RE: Final Soil Vapor Extraction System Effectiveness Zone 6 Optimization Report, Hartford
Petroleum Release Site, Hartford, Illinois

USEPA COMMENTS DATED AUGUST 2, 2016 AND APEX OIL COMPANY, INC. RESPONSE DATED AUGUST 26, 2016

Apex Oil Company, Inc. Response to USEPA Comments
Draft Soil Vapor Extraction System Effectiveness Zone 6 Optimization Report
Hartford Petroleum Release Site, Hartford, Illinois

TITLE: FIGURE 19. VAPOR AND WATER FLOW RATE MEASUREMENT EQUIPMENT DETAILS

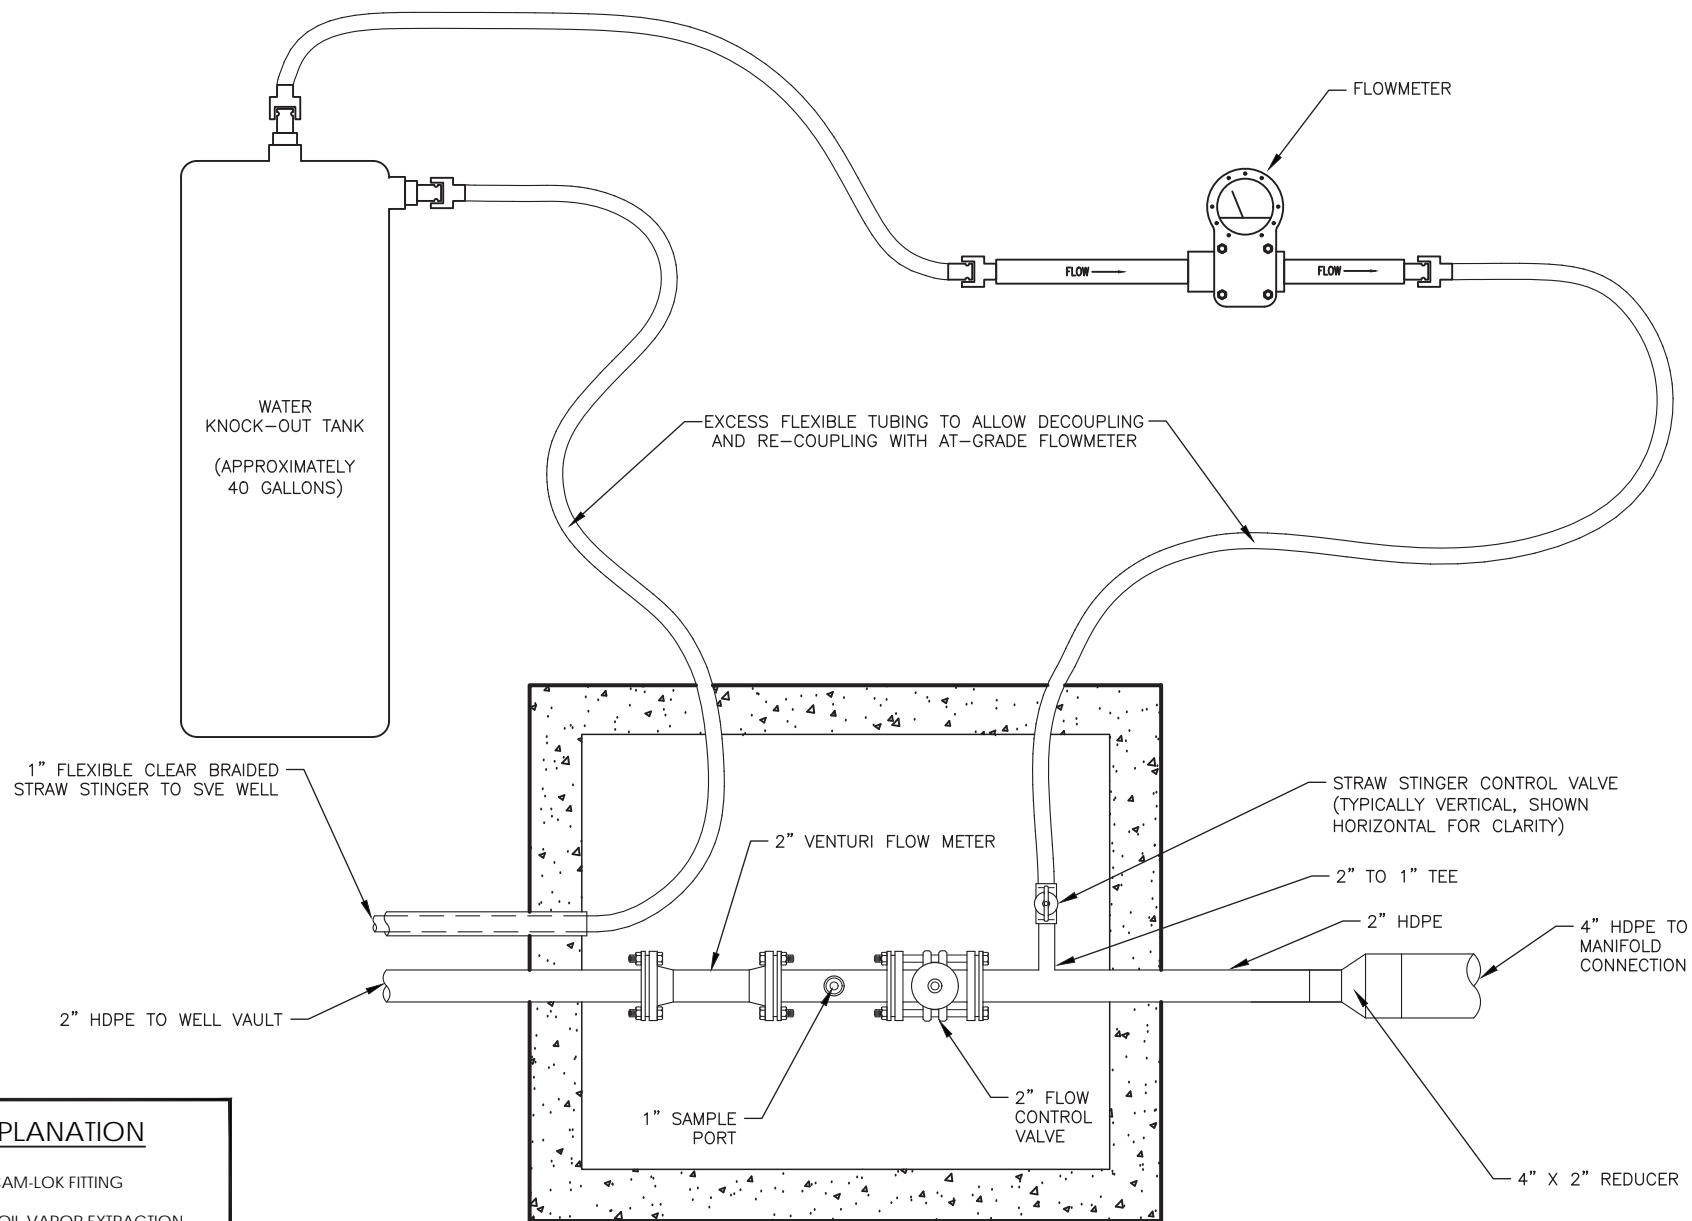
| Comment Number | Sub-section | Topics of Discussion | Recommended Revisions |
|--------------------------|---|---|---|
| 10 | 4-1 – Methods; Figure 19 | Water removal rates and air flows were measured once per day by temporarily connecting the 40-gallon knock-out tank and a flowmeter to the vacuum header. The majority of the measurements were performed using 5-minute intervals per day for each well. This method would not provide reliable data because the water removal rates and air flows during the majority of operation would differ from those during the short-time measurement intervals. More reliable data would be obtained by using an electrical pump operated by level switches and a flow totalizer to evacuate liquid from the knock-out tank in a continuous flow fashion during the test. | It is recommended that the report clarify the limitations of data representativeness for water removal rates and air flow measurements obtained during knock-out tank performance testing and that as a result, the water removal rates and totals volumes provided are order-of-magnitude estimates. |

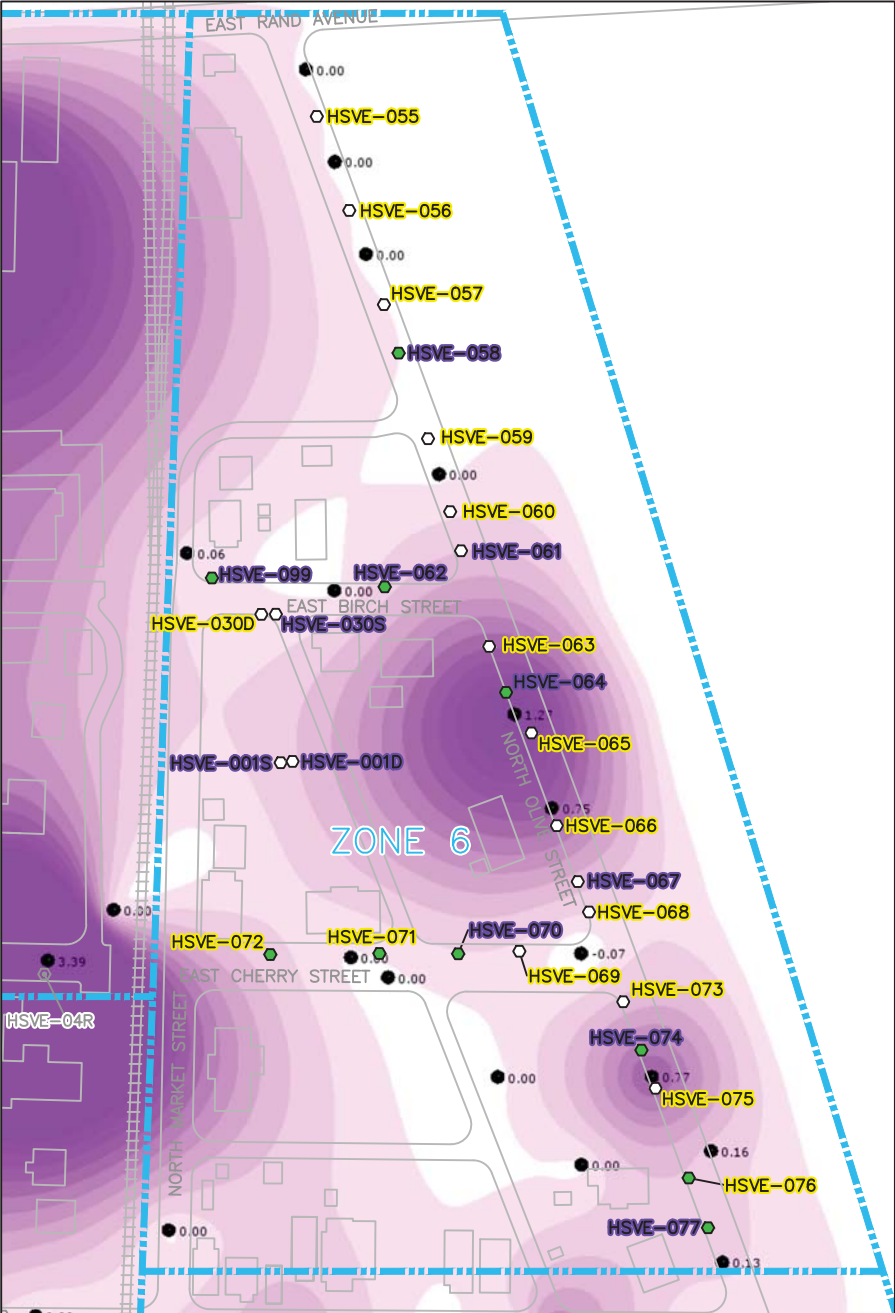
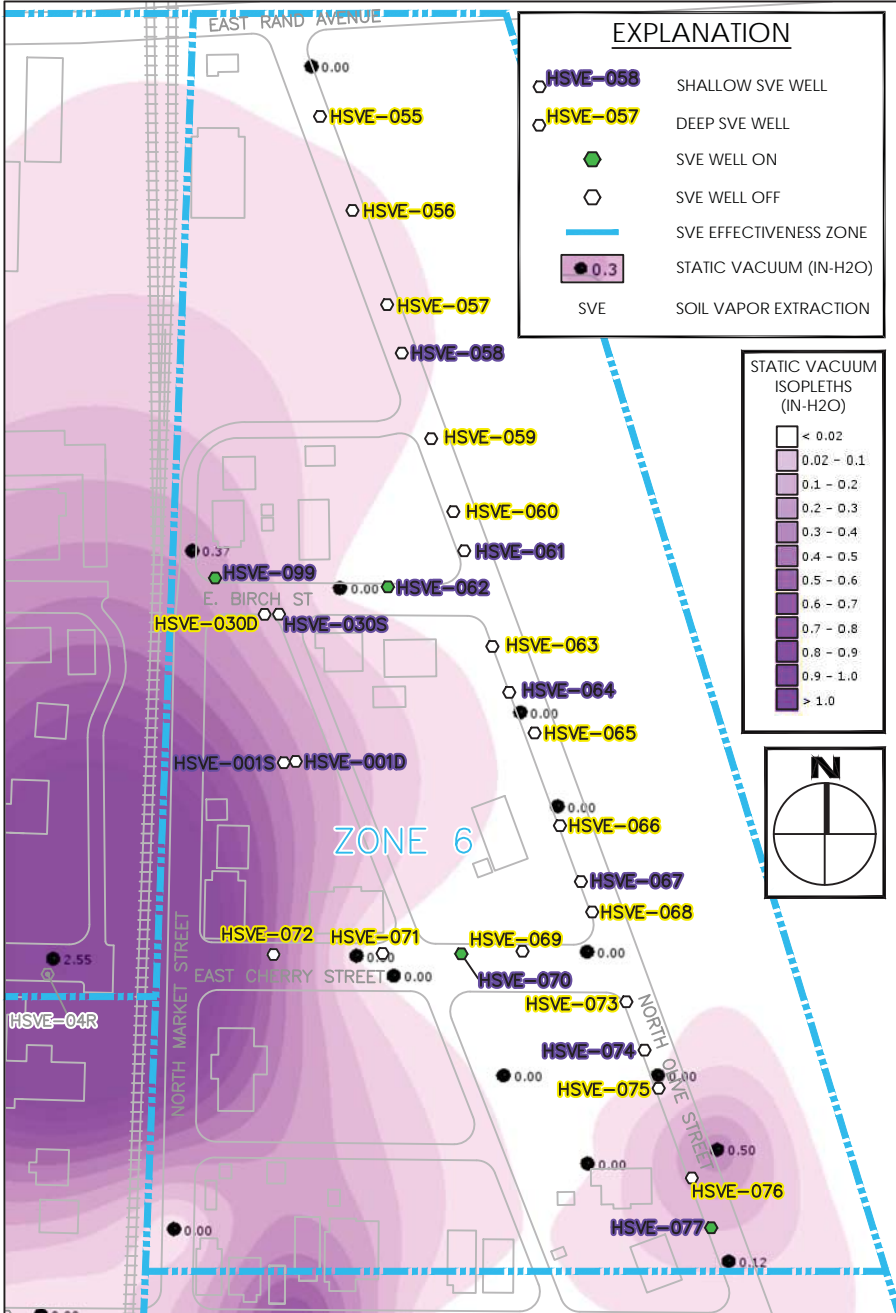
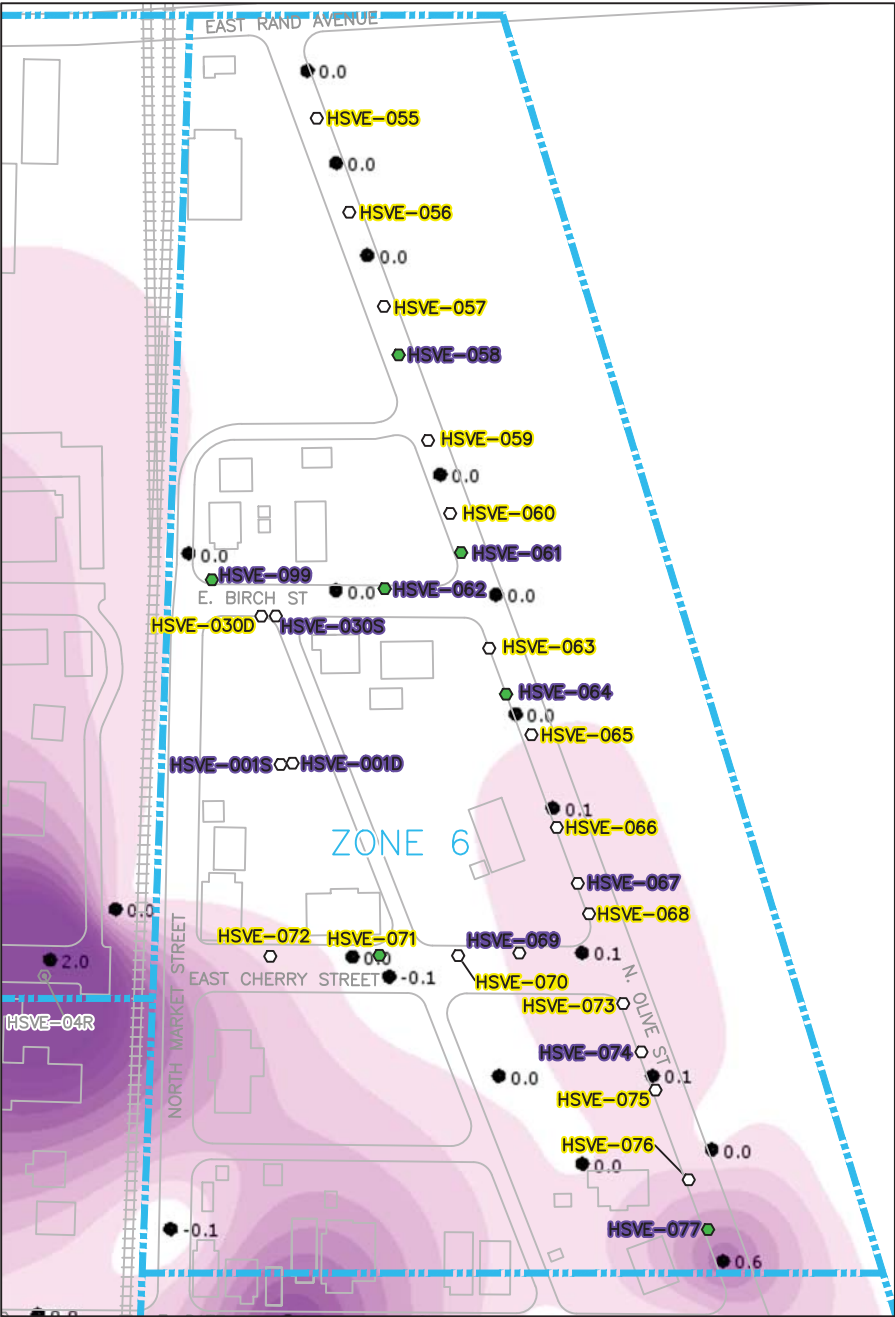
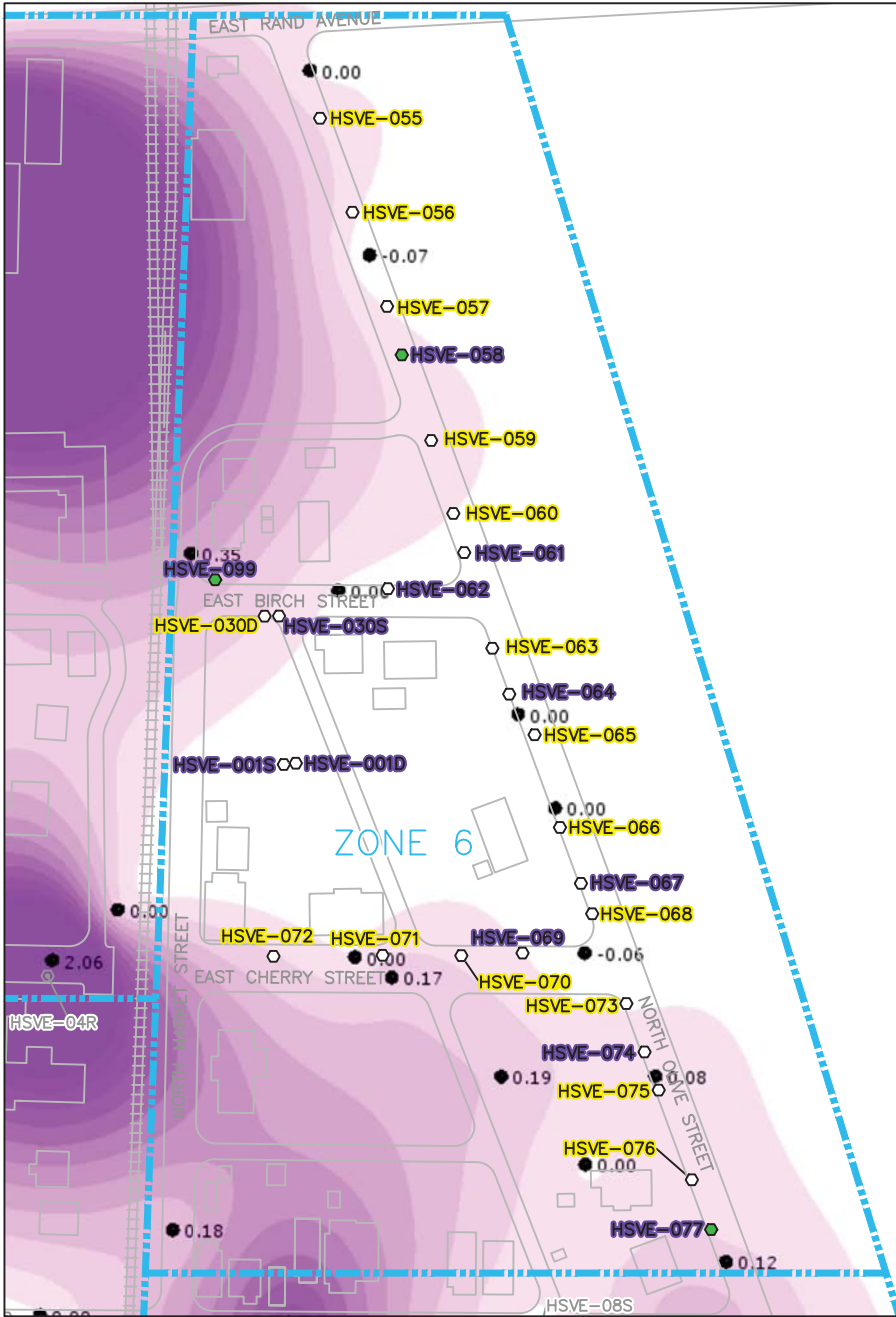
| Comment Number | Sub-section | Topics of Discussion | Recommended Revisions |
|--|--|---|--|
| 15 | Figure 20. | Vapor probes vacuum monitoring results. Vapor probe identification numbers are not shown on the figure. | It is recommended that the vapor probe identification numbers be added to Figure 20. |

| Comment Number | Sub-section | Topics of Discussion | Recommended Revisions |
|--|--|---|--|
| Response to Comment 15 | The vapor probe locations and identifications that were used to create the four vacuum distribution isopleth maps for Zone 6 included on Figure 20 have been provided on Figure 4. It would not be feasible to add the individual locations or identifications to the isopleth maps provided on Figure 20. | | |
